2514 DEXTER AVE NORTH

ADMINISTRATIVE DESIGN REVIEW - RECOMMENDATION PACKET

SDCI Project # 3032686-LU

WRAPPED BALCONIES (NORTH-EAST)

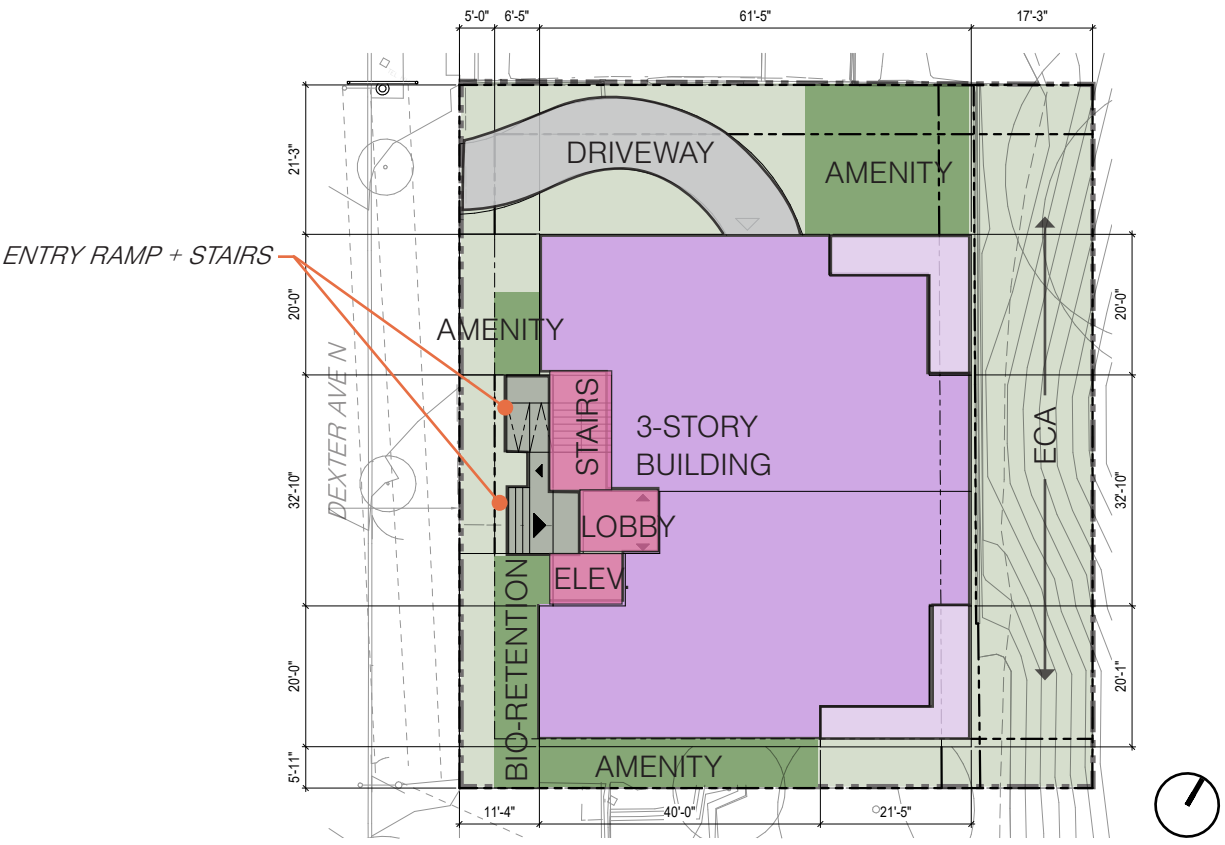
Board Guidance: Staff is open to carved-out balconies wrapping the corners along the east facade as well as a shed roof.

Design Response: Carved-out balconies wrap the corners. A shed roof was incorporated (see page 13).

PROPOSED STAIR ORIENTATION (NORTH-SOUTH)

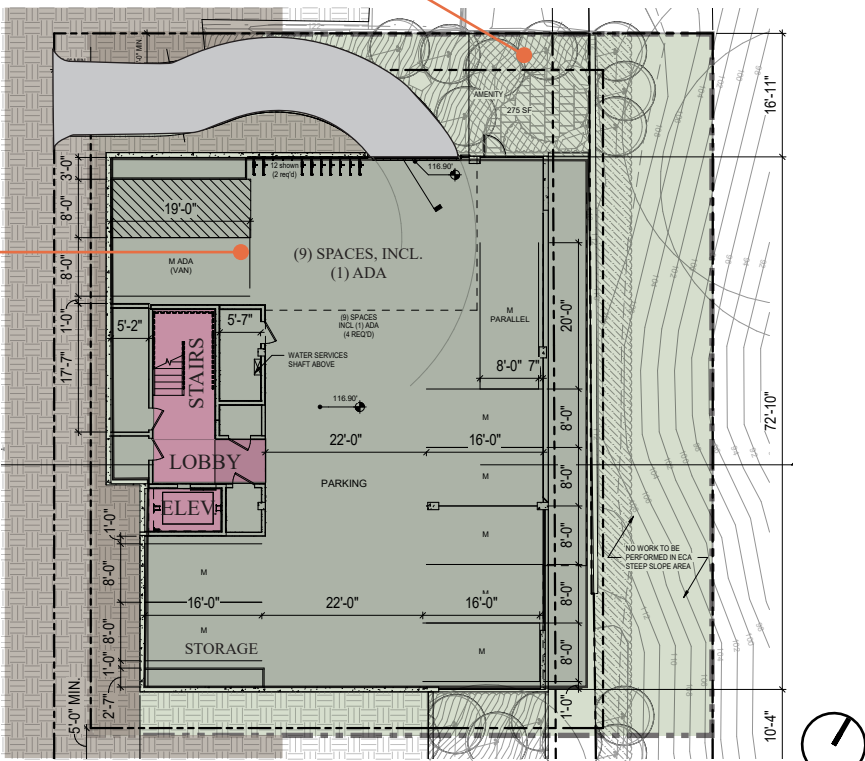
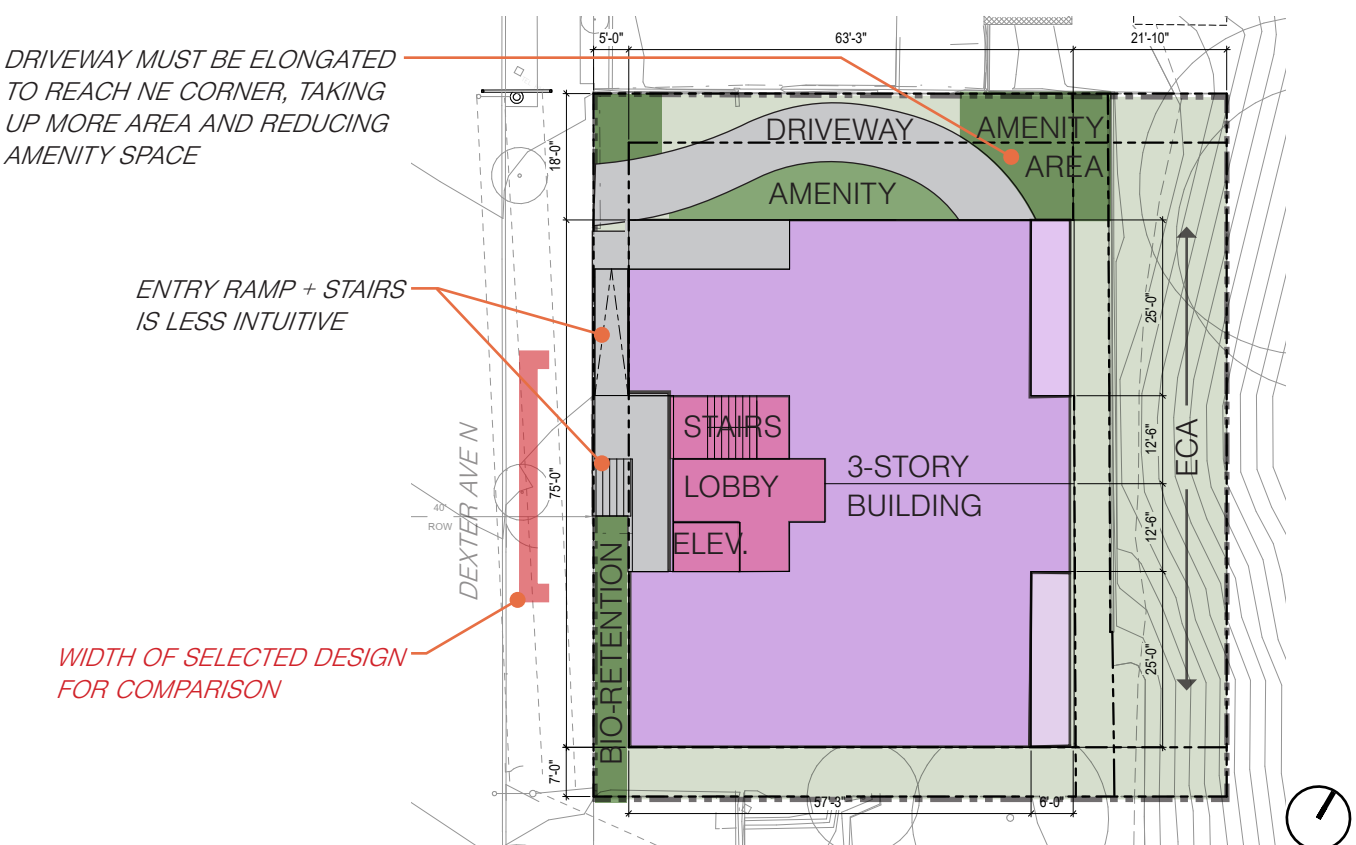
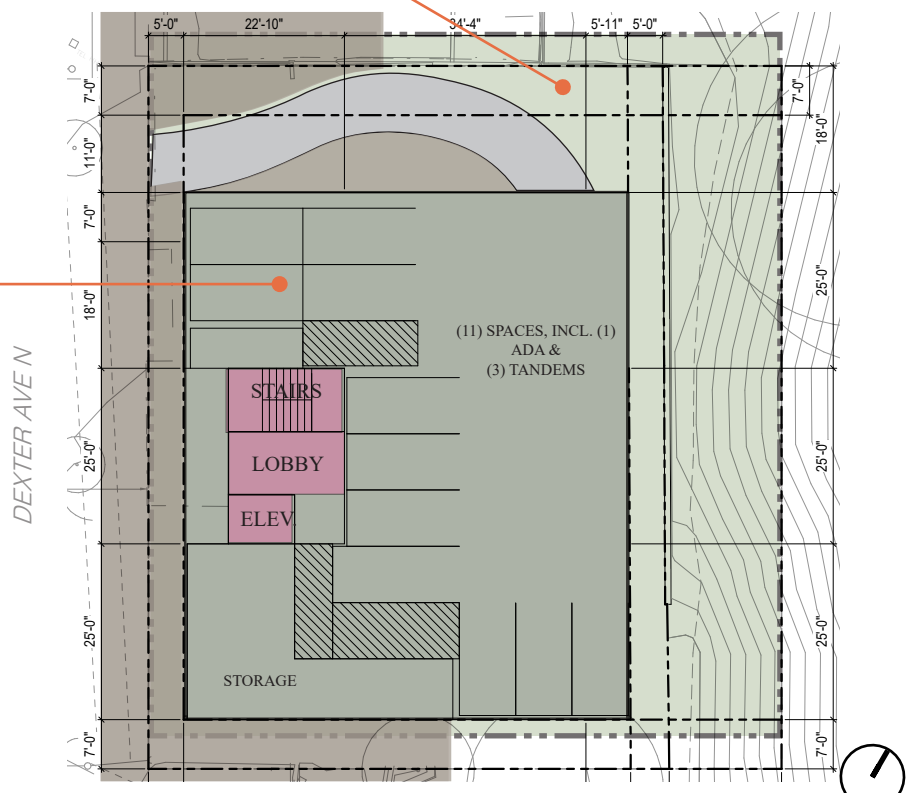
Board Guidance: Staff supports centralized entry directly connected to the street. Staff recommends study to consolidate circulation elements into a single form.

Design Response: Centralized entry connecting directly to the street has been maintained. As requested, an E-W orientation of the stair was studied (see page 8). The N-S orientation shown at EDG was maintained because of negative impacts to parking and on-site landscaped open space. Furthermore, the proposed stair orientation emphasizes the element as a primary design feature of the street-facing facade. Consolidating the stair and elevator onto one side of the lobby is not feasible because of the negative impacts on parking circulation (internal and external) and internal circulation between the units and upper floor lobbies.

PREVIOUS DESIGN

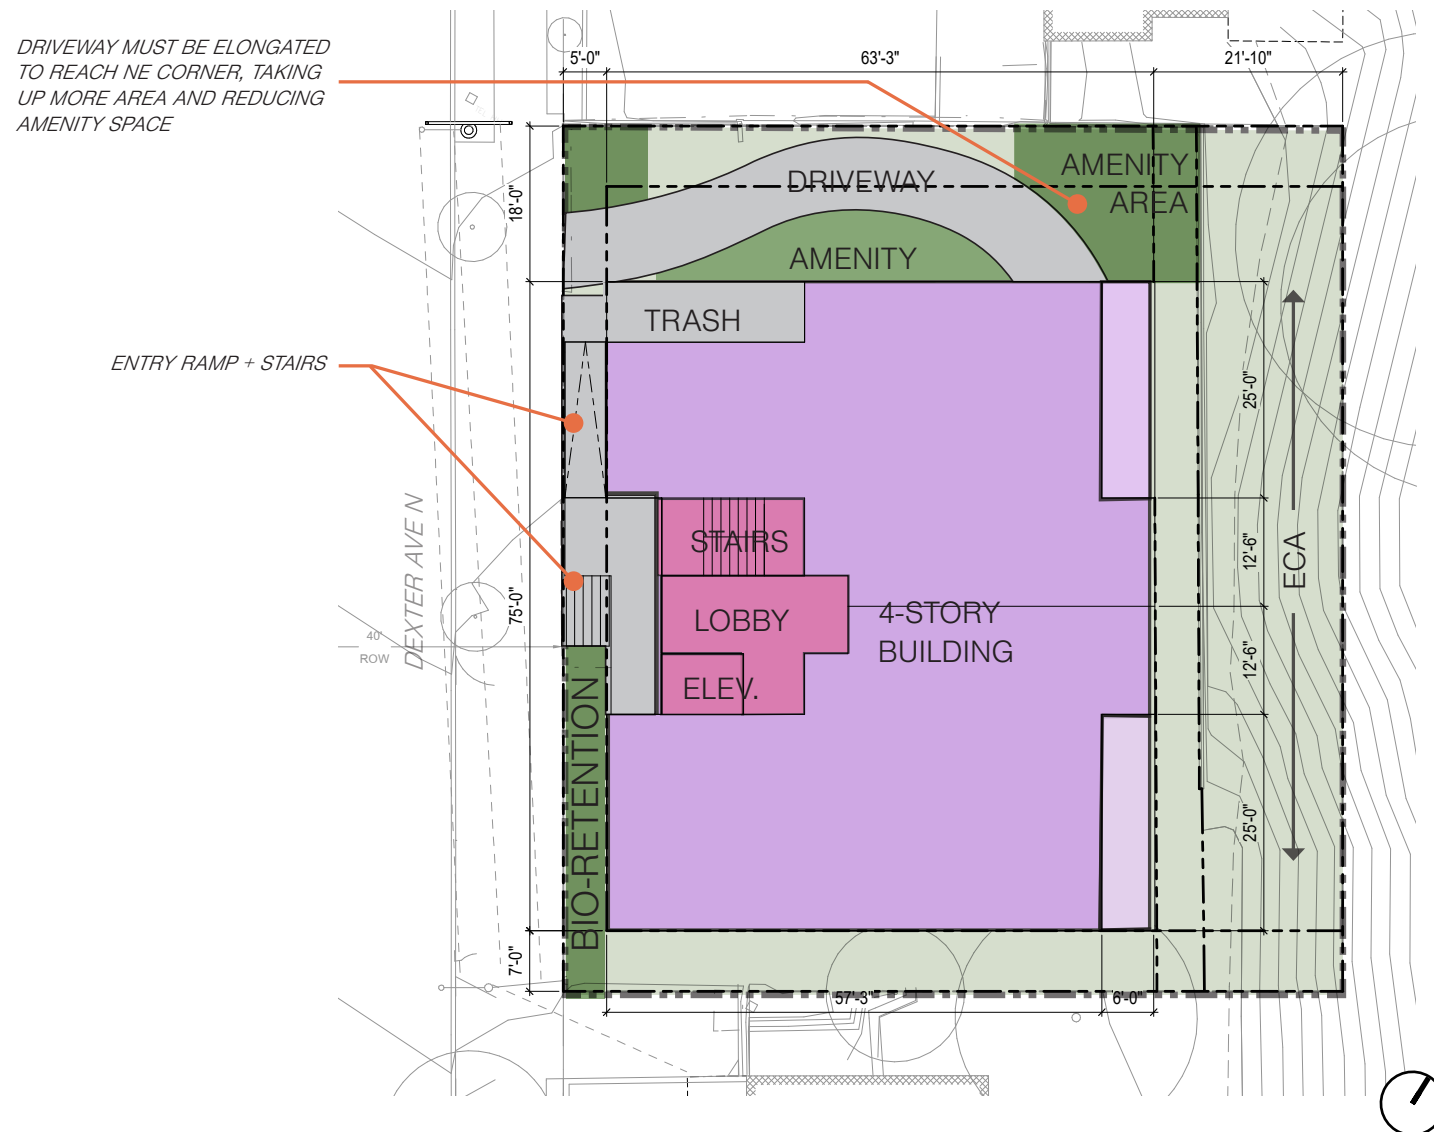
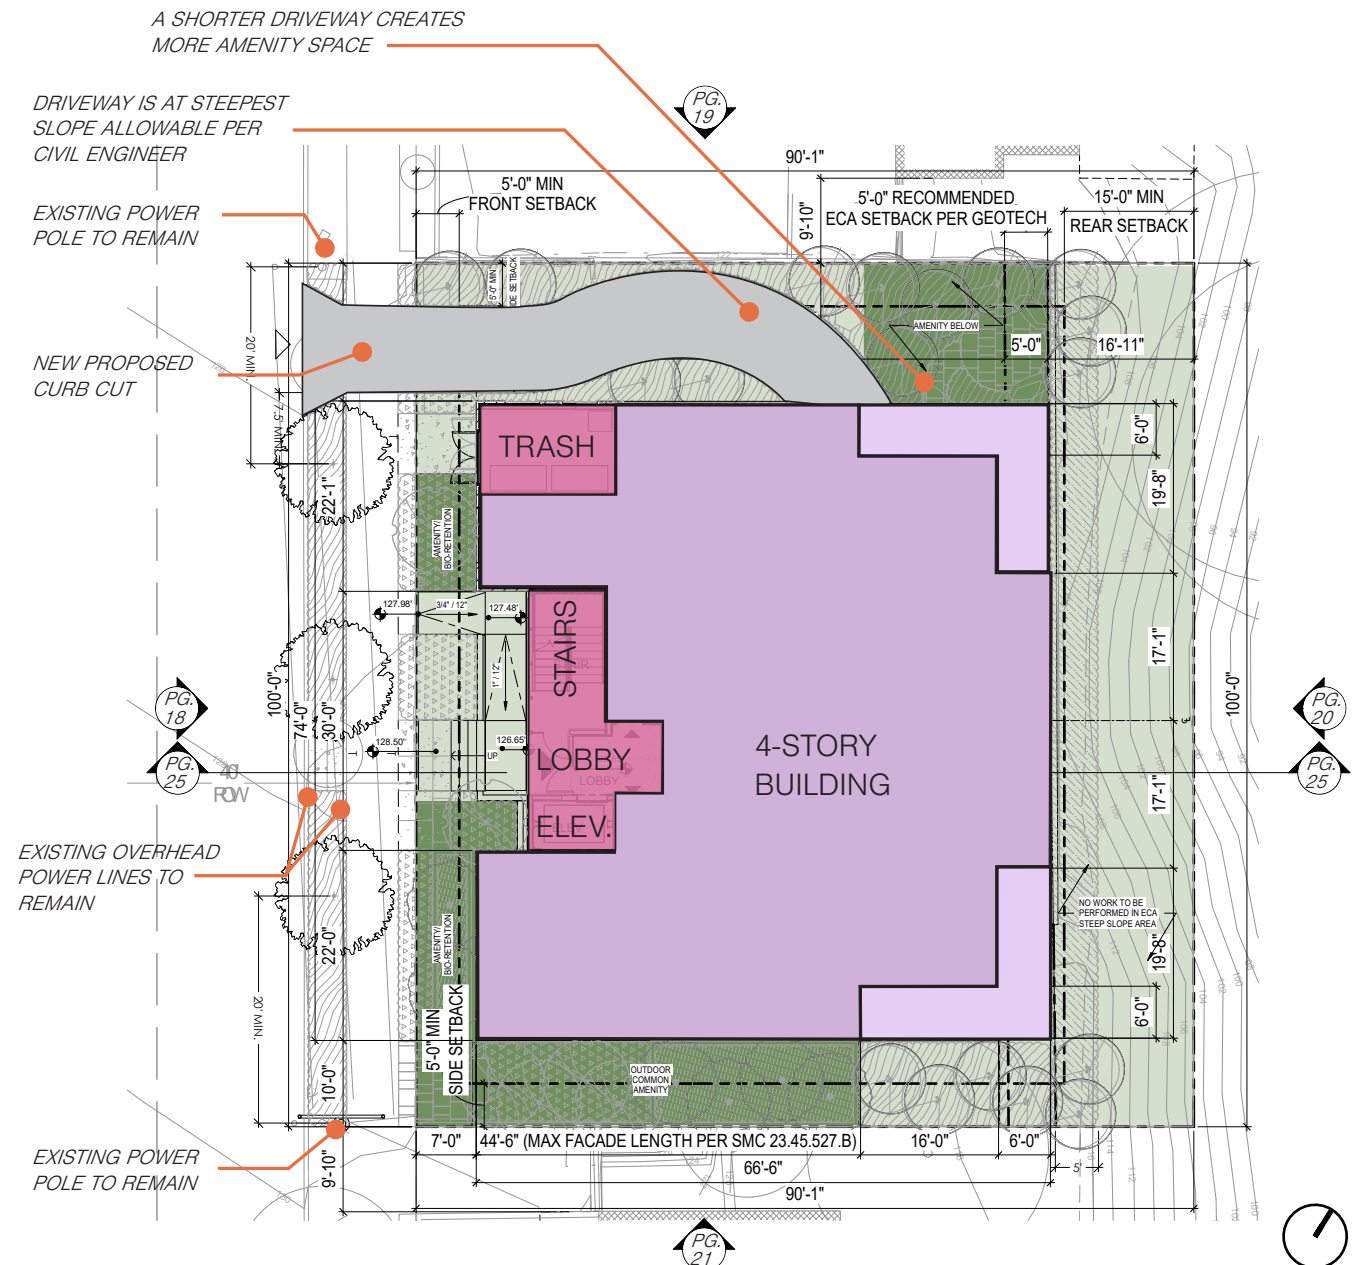
Board Guidance: Staff recommends exploring alternative driveway configurations to reduce the overall impact of the driveway on the site design and function of the amenity area.

Design Response: Driveway configuration have been studied closely in collaboration with the landscape architect and civil/structural engineers. The team has received a variance approval from both SDOT and SCL to reduce our power pole clearance from 7'-6" to 4'-1", allowing the building to shift northwest. Moving the building northwest to reduce the overall impact of the driveway also reduced the proposed parking by 2 stalls, but the project was able to retain a 1:1 parking-to-unit ratio (excluding the addition ADA stall).

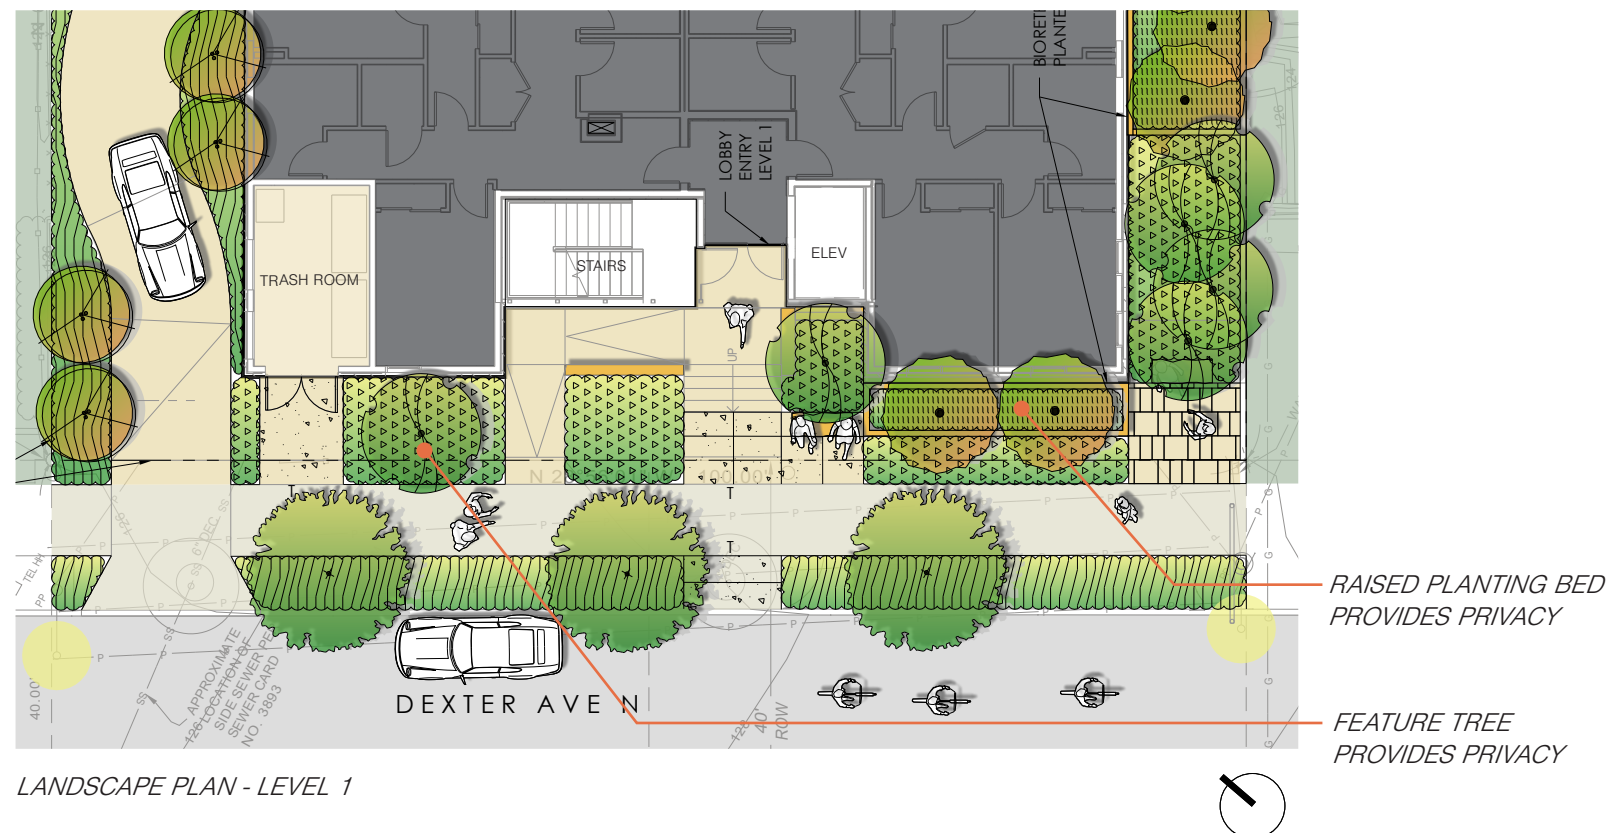
Board Guidance: Thoughtfully design the setback area and landscaping to create a buffer which provides privacy and security for ground-level units.

Design Response: Landscaping, including trees and bio-retention planters, is proposed in the transition zone between the sidewalk and ground-level dwelling units. Operable metal screens have been added at all windows facing Dexter Avenue to provide privacy at these units.
